SCHWEIZER SERVICE BULLETIN

C1B-032.1*
28 Feb 2012

SUBJECT: INSPECTION AND MODIFICATION OF TAILBOOM SUPPORT STRUT ADJUSTABLE DIAMETER BOLT

Figure C1B-032-1. Tailboom Support Strut Adjustable Diameter Bolt Inspection and Modification

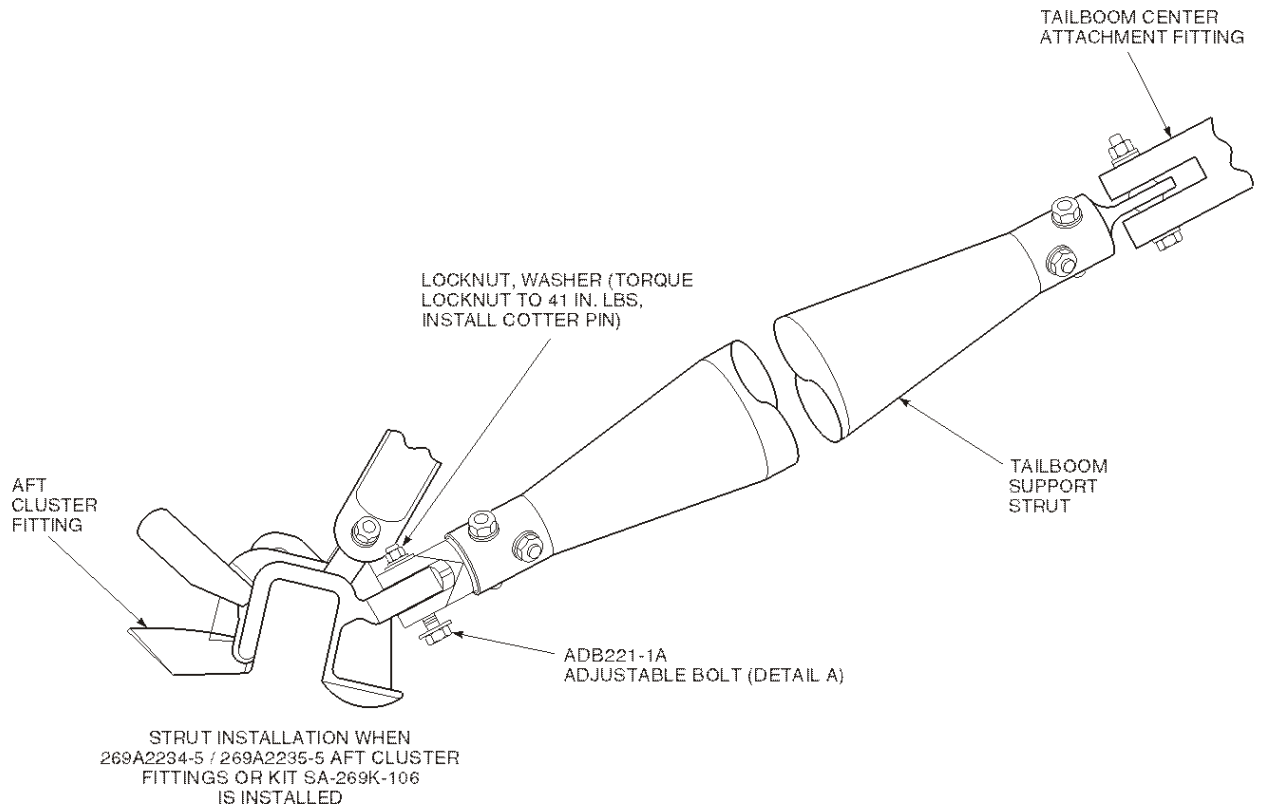
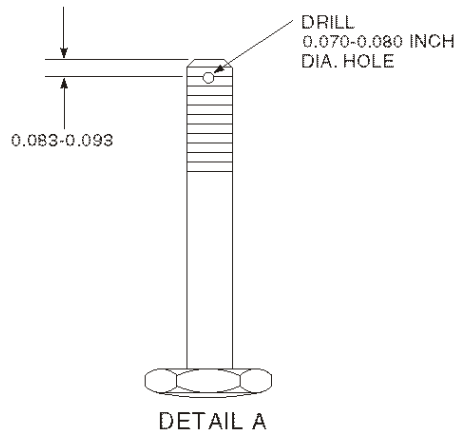
- Schweizer Aircraft received a report that a tailboom support strut adjustable diameter bolt came loose and departed the helicopter. An investigation concluded that the locknut holding the adjustable diameter bolt in place worked loose during flight.
- This service bulletin contains two parts:
 - Part I requires the operator to immediately verify that there is sufficient drag torque on the left-hand and right-hand locknuts, and that both locknuts are properly torqued.
 - Part II provides instructions to modify the ADB221-1A adjustable diameter bolt to allow the addition of a secondary safety mechanism. An ADB221-1B may be installed in lieu of the modified ADB221-1A.
- Both parts of this service bulletin must be complied with.

- a. See Figure C1B-032-1 and note locations of aft cluster fittings and adjustable diameter bolts.
- b. Loosen MS21043-3 locknut and verify turning (drag) torque of at least 2 in-lbs.
 1. If 2 in-lbs or greater drag torque has been verified, re-torque locknut to 23 in-lbs. plus a maximum drag torque of 18 in-lbs. for a final torque of 41 in-lbs.
 2. If drag torque is less than 2 in-lbs, replace with new MS21043-3 locknut and torque locknut to 23 in-lbs. plus a maximum drag torque of 18 in-lbs. for a final torque of 41 in-lbs.
- c. Record compliance with Part I of this service bulletin in the helicopter records.

- a. Remove ADB221-1A adjustable diameter bolt from helicopter.
- b. Modify bolt as follows:
 1. Remove bolt from adjustable assembly and retain all parts.
 2. Secure bolt in drill vise.
 3. Using a drill press, drill 0.070-0.080-inch diameter hole through threaded portion of bolt, centered 0.083-0.093-inch from end of bolt as shown in Figure C1B-032-1.
 4. Chase threads of bolt to remove any burrs.

- c. Reassemble washer and bushings onto bolt in accordance with Basic HMI, Section 11.
- d. Install adjustable diameter bolt (Basic HMI, Section 11).
- e. Install new MS21043-3 locknut on bolt and torque locknut to 23 in-lbs. plus a maximum drag torque of 18 in-lbs. for a final torque of 41 in-lbs.
- f. Install MS24665-132 or MS24665-151 cotter pin on adjustable diameter bolt.
- g. Record compliance with Part II of this service bulletin in the helicopter records.
